## West Oaks I Renovation JSP14-57

# PLAN REVIEW CENTER REPORT

**JSP14-57**

Revised Preliminary Site Plan

ORIGINAL  
ISSUE DATE: DEC. 18, 2014  
PEA JOB NO. 2014-166  
SCALE: 1" = 20'  
DRAWING NUMBER:  
**C-3.1**

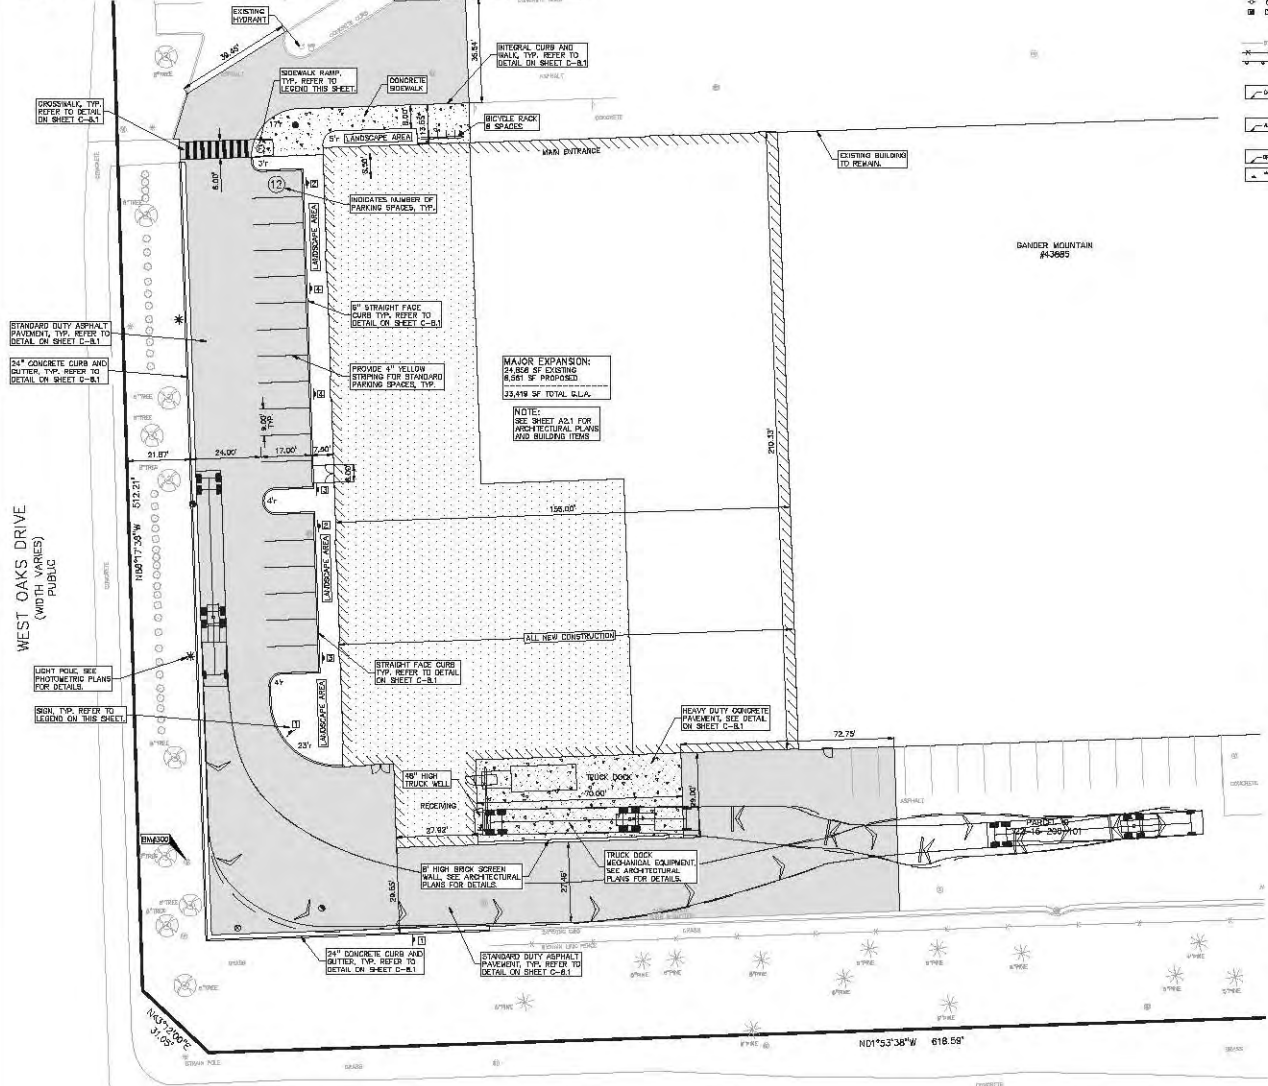
2. General note 1 on sheet C-3.1 is inconsistent with the dimensioning of the parking spaces along the north end of the building. Those spaces are correctly designed and dimensioned as 17 ft long to the face of curb, but the note appears to indicate that such dimensions are to back of curb. **Note 1 should be revised to specifically state that “parking space dimensions – length as well as width – are referenced to the face of curb or walk.”**

1. The labels will be revised to read '4" Concrete Straight Face Curb, Typ. Refer to Detail on Sheet C-8.1'
2. Note 1 will be revised to specifically state that "parking space dimensions – length as well as width – are referenced to the face of curb or walk"
3. A note will be added to the plan specifying all signs shall be placed a minimum of 2 feet behind the back of curb.
4. No parking fire lane signs will be added in the landscaping area on the north side of the drive aisle. Note 4 will be revised accordingly.
5. The sign legend will be retitled to sign quantities and it will include the quantities of each sign type required.
